AGENDA
City of Gig Harbor Design Review Board
Virtual Meeting of February 25, 2021 at 5:00 pm

**COMMUNITY DEVELOPMENT DEPARTMENT
PLANNING DIVISION
STAFF REPORT**

RE: PL-DR-20-0071 – Gig Harbor Peninsula FISH Food Bank
Public Meeting Date: February 25, 2021

SITE SECTION A-A

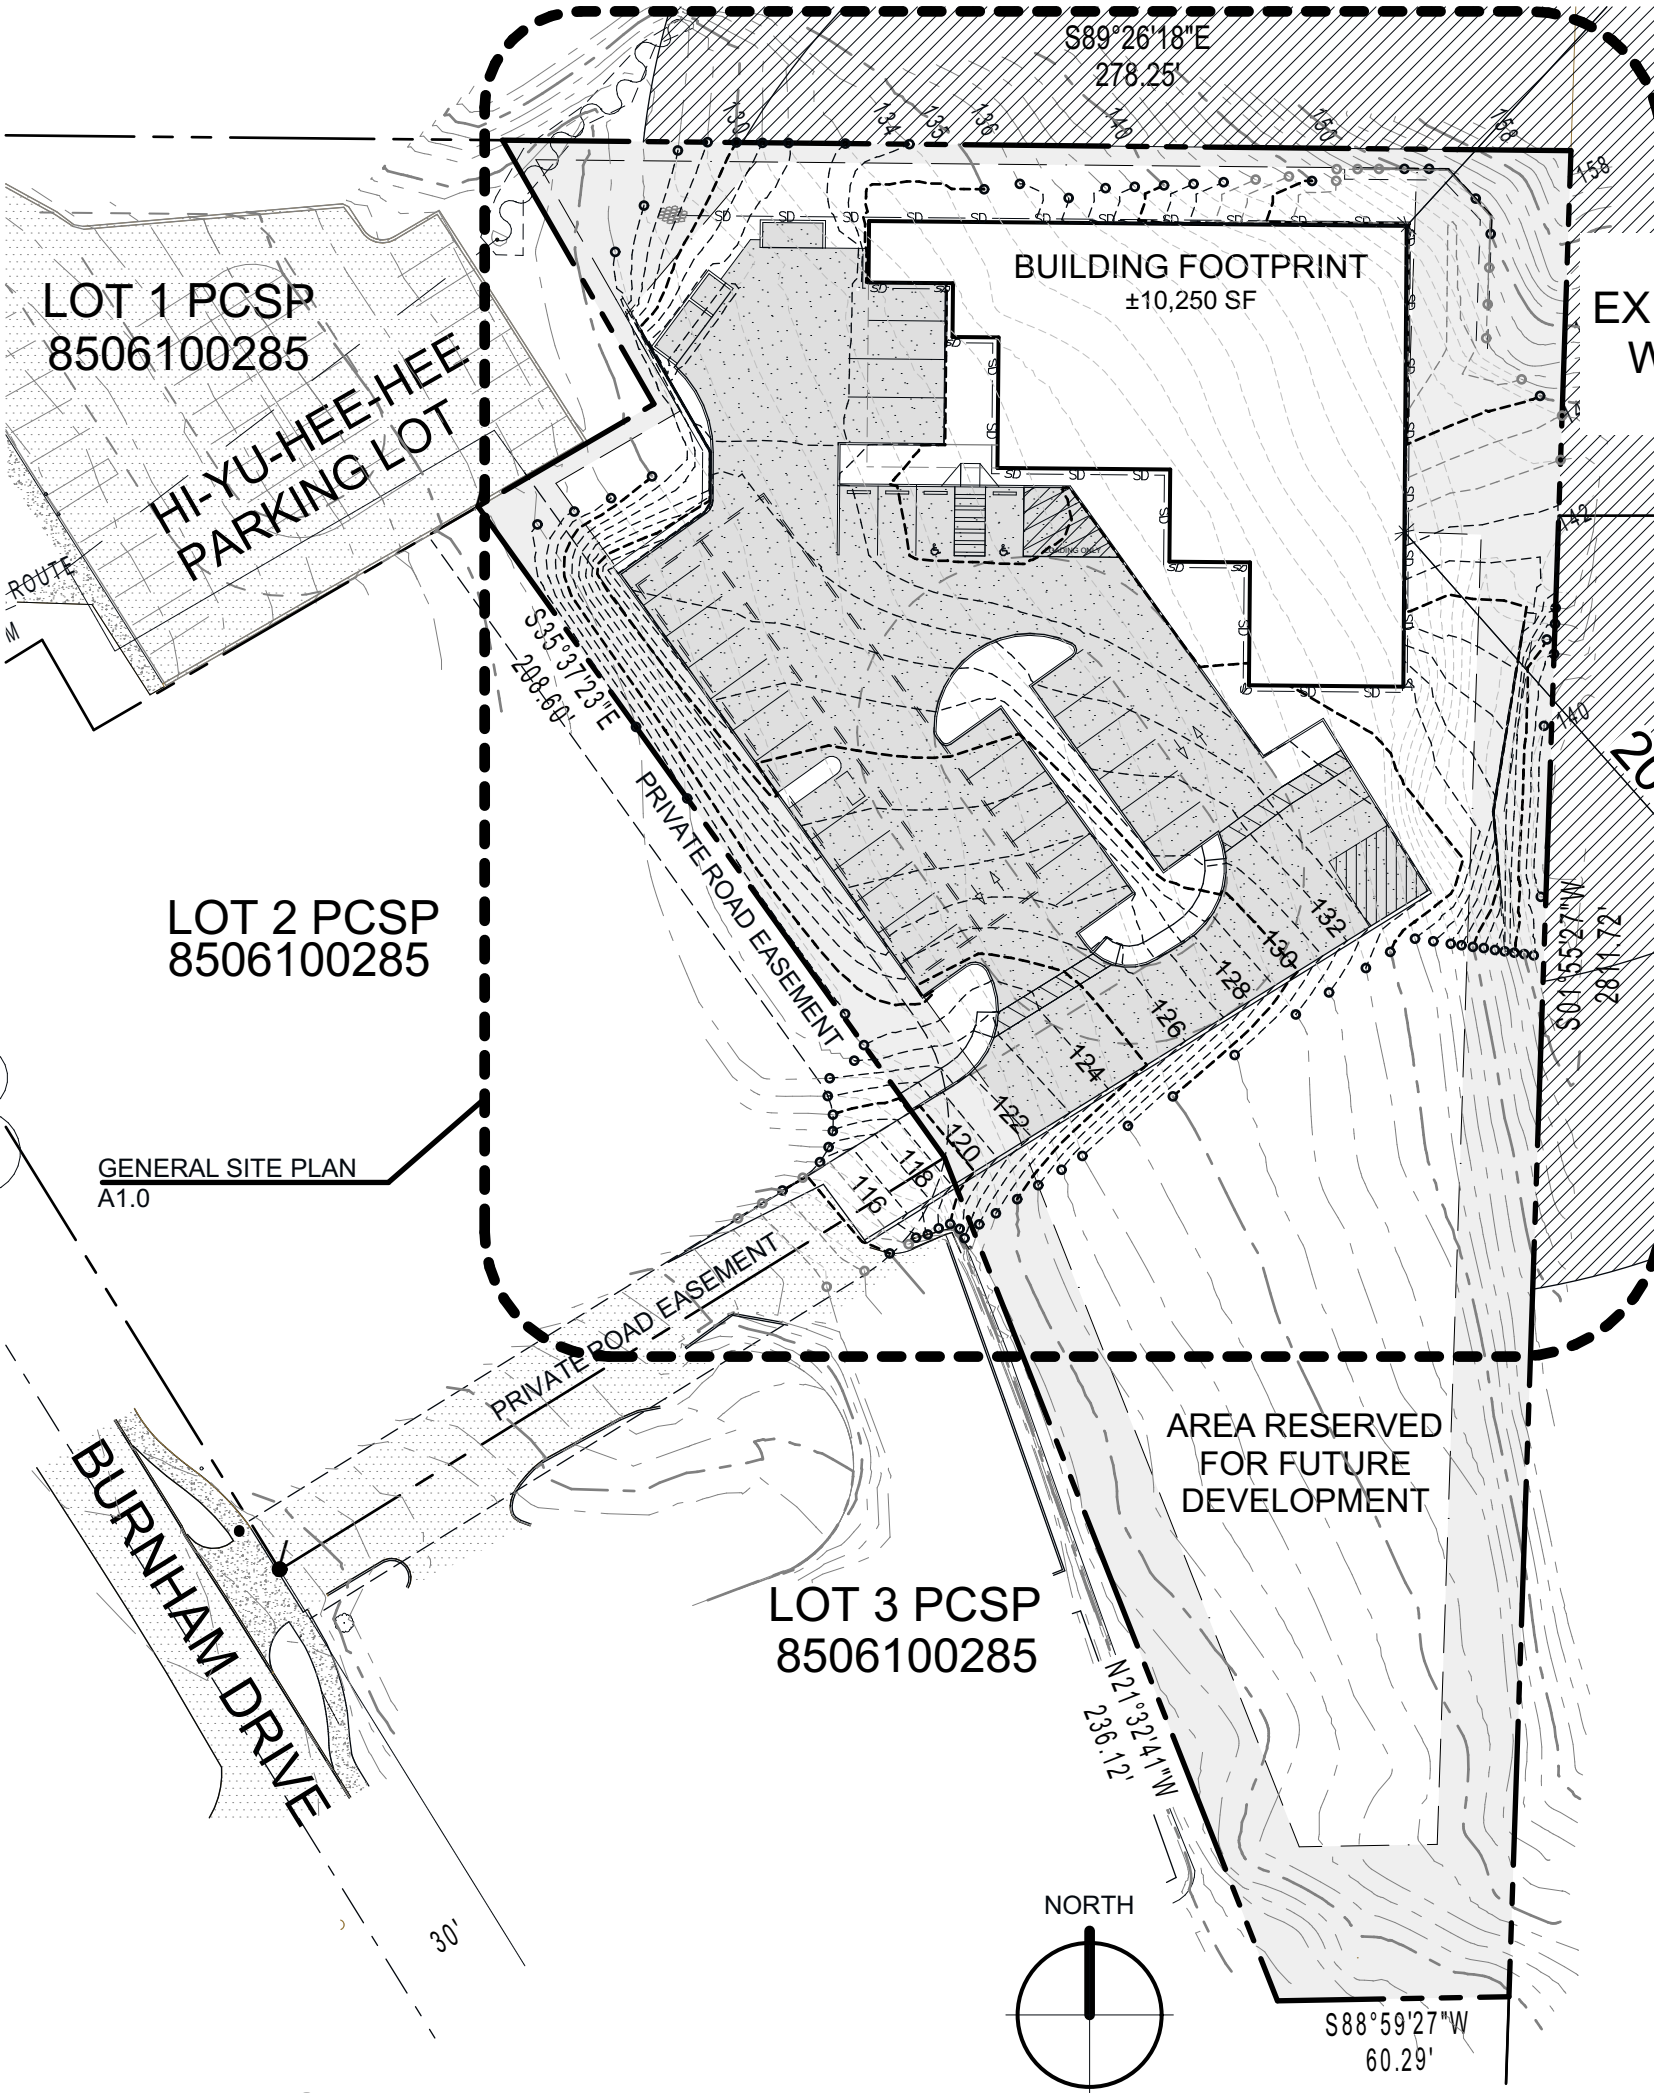
Referencing the site section on sheet A1.0 of Exhibit A, the applicant appears to design the site in a manner which maintains the natural topography other than that grading activity necessary to create a level building area and Code-compliant site access. The intent of GHMC 17.99.240(C) is to design a site in a manner which complements and takes advantage of the natural topography; this intent is displayed in the applicant's Elevations (Exhibit A), wherein the retention of existing slopes surrounding the building pad are evident.

In this limited instance, the DRB may wish to consider that the site design retains these features and that no element of the applicant's grading plan requires the installation of retaining walls in excess of six-feet, allowing the buildable area to be developed within the natural topography as much as practical. The DRB may also wish to consider that, while the difference in cut and fill percentages have increased since the applicant's last alternative design proposal to the DRB on August 13, 2020, the overall grading activity has reduced; the applicant has reduced the cut activity by 2,500 cubic yards and the fill activity by 500 cubic yards, representing less manipulation to the site's natural topography than had been previously reviewed by the DRB and found to meet the criteria set forth in GHMC 17.98.055(A) to recommend approval of an alternative design proposal.
